Access Compliance Report

Public Rights-of-Way

(Curb Ramps)

Intersection ID: 42748	Main Street: BACK_ACRE_DR	Cross Street: BARCLAY_FOREST_DR	Location: SW
ADA ID: C1E217523852	Ramp Type: PerpDiag	Initial Pass/Fail: Fail	Overall Compliance: No
Severity Score: 33.75			
Codes/Mitigation Info/Possible Solution		Field Measurements/Component Compliance

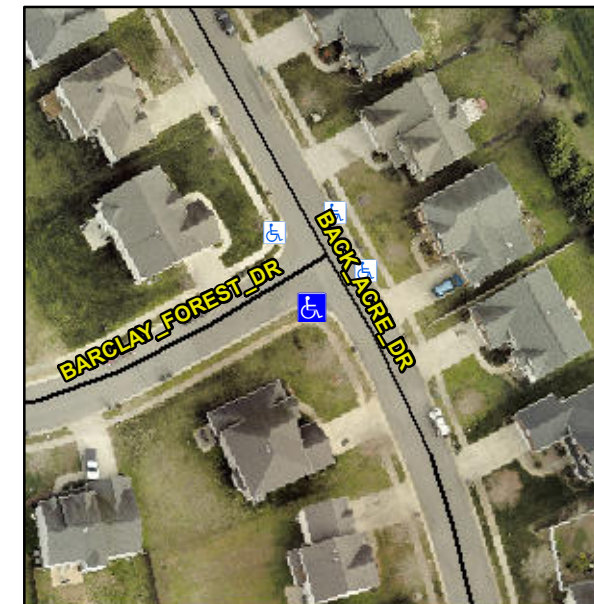
Not Found, R304.5.1, R304.5.3

Compliance	Description	Data	Compliance	Description	Data
N/A	Ramp Length (in)	48.0	Yes	Ramp Slope (%)	5.3
No	Ramp Width (in)	47.5	No	Ramp XSlope (%)	9.5
N/A	Flare Type LT	N/A	N/A	Flare Type RT	N/A
N/A	Flare Slope LT (%)	N/A	N/A	Flare Slope RT (%)	N/A
N/A	Flare Traversable LT?	N/A	N/A	Flare Traversable RT?	N/A
N/A	Landing Length (in)	N/A	N/A	DWS Provided?	N/A
N/A	Landing Width (in)	N/A	N/A	DWS Contrast?	N/A
N/A	Landing Slope (%)	N/A	N/A	DWS Length (in)	N/A
N/A	Landing X Slope (%)	N/A	N/A	DWS Full Width?	N/A
N/A	Landing Curb? (Y/N)	N/A	N/A	DWS Offset (in)	N/A
N/A	Shared Landing?	N/A			
N/A	Gutter Ponding?	N/A	N/A	Gutter Slope (%)	N/A
N/A	Gutter Lip Ht (in)	N/A	N/A	Gutter X Slope (%)	N/A
N/A	Painted X Walk1?	No	N/A	Painted X Walk2?	No
	X Walk 1 Direction	To SE		X Walk 2 Direction	To NW
N/A	X Walk 1 Width (in)	N/A	N/A	X Walk 2 Width (in)	N/A
	X Walk 1 Slope (%)	0.0		X Walk 2 Slope (%)	5.3
	X Walk 1 X Slope (%)	6.9		X Walk 2 X Slope (%)	3.8

N/A	Ramp inside XWalk1?	N/A	N/A	Ramp inside XWalk2?	N/A
	Road Slope (%)	6.7	N/A	Clear Space?	N/A
	Road X Slope (%)	2.2	N/A	Clear Space to XWalk (in)	N/A
N/A	Any Obstructions?	N/A	N/A	Storm Grate/Utility Hazard?	N/A
	Obstruction Type			Storm Grate/Utility Type	
		N/A			N/A
			Yes	Surface Condition? (G/P)	Good

Remove & Replace Curb Ramp With Two New Directional Ramps or Equivalent.
